FINAL NAVAL AIR STATION ALAMEDA Restoration Advisory Board (RAB) Meeting Minutes

July 12, 2012

Re: IR Site 2 Draft Remedial Action Work Plan 90%

Remedial Design Installation Restoration Site 34 Alameda Point, California

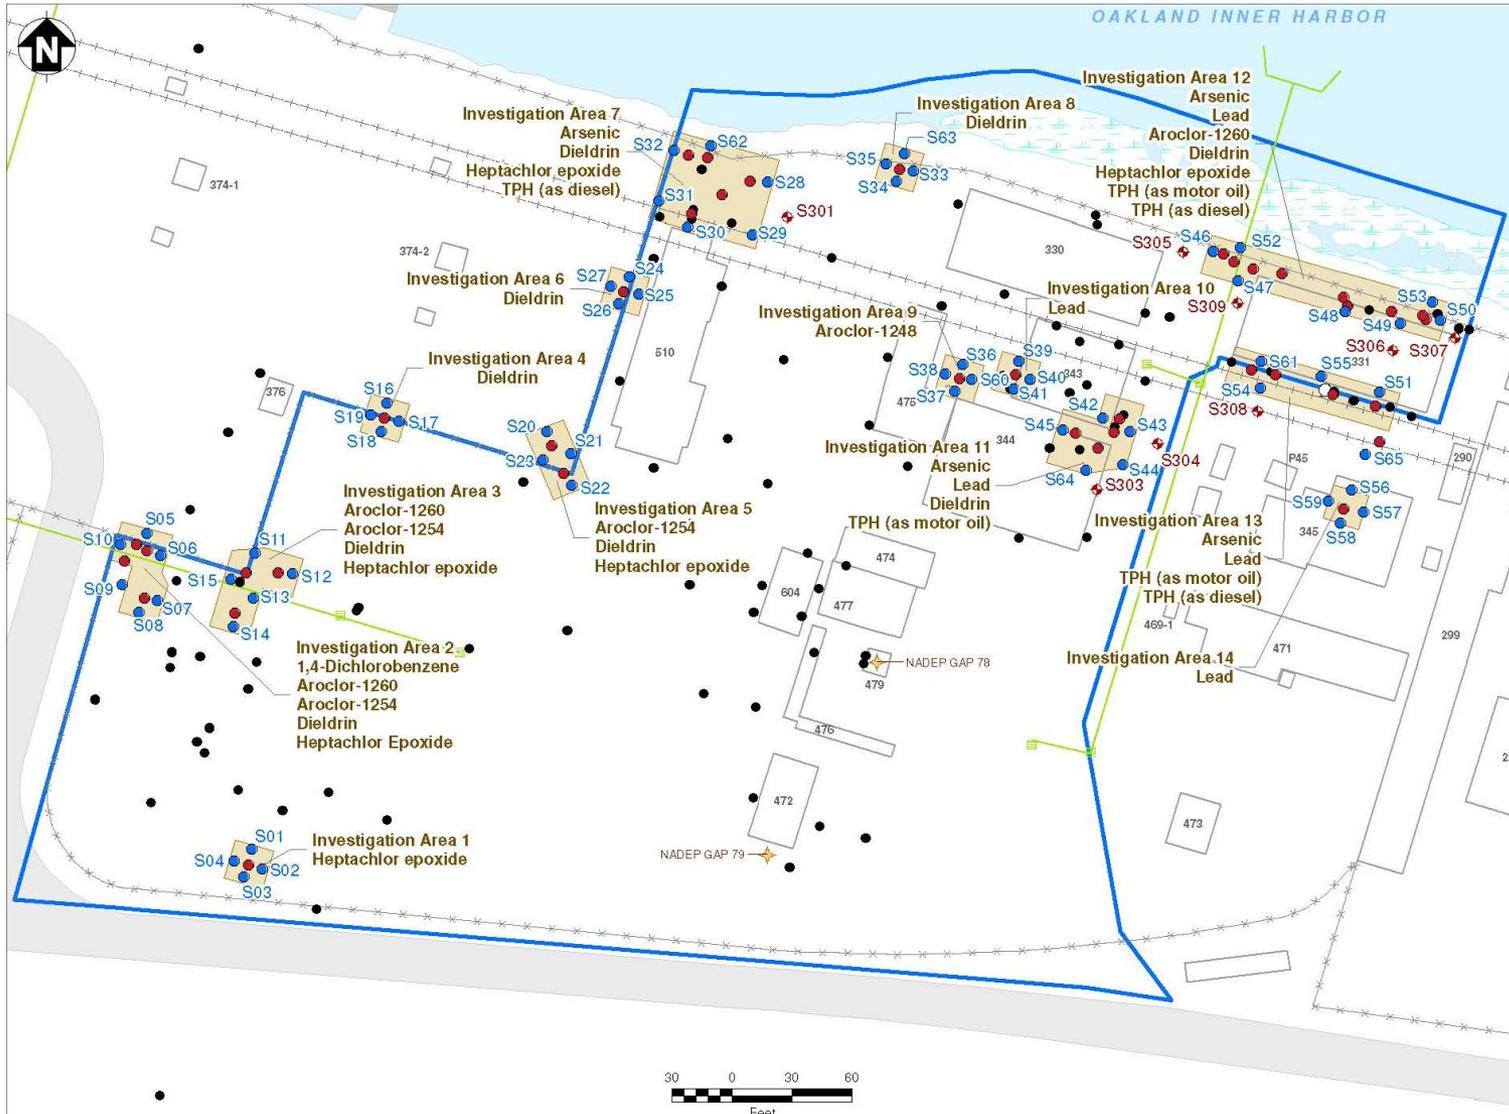
During the review of slide 7, Daniel Hoy (RAB member) asked how the locations for the initial samples were determined. Mr. Guiang said they were biased towards areas where certain historical activities had occurred, then other samples were collected over a grid pattern. He clarified that the black and red dots represented sample locations from previous investigations, and that the red dots represent locations where contaminants were reported at levels that exceeded their respective remedial goals.

During the review of slide 11, Mr. Peterson asked for clarification about what the different colored dots represented. As noted earlier, Mr. Wittenberg said the black and red dots are both from previous investigations; red dots are where contaminants were reported at levels exceeding their respective remedial goals. The blue dots shown on Slide 11 are the locations where pre-design samples were collected. The results of the pre-design sampling are not represented on the map.

Mr. Peterson asked if the light outlines were the location of buildings and, if so, why the contamination seems to be located all along the buildings. Mr. Wittenberg said the outlines are structures and the contamination is likely from lead-based paint (LBP), which was historically painted on the outside of the structures. He added that arsenic is often associated with LBP. Dr. Gottstein said arsenic is also often used as a rodenticide and asked if that could explain the presence of arsenic. Doug deHaan (Alameda Council member) said he used to work at AP when it was an active station and this area was used as a plating operation. Barges from Point Molate would discharge their fuel in the area and the fuel contained lead. That is why fuel and lead contamination are found together in the ground.
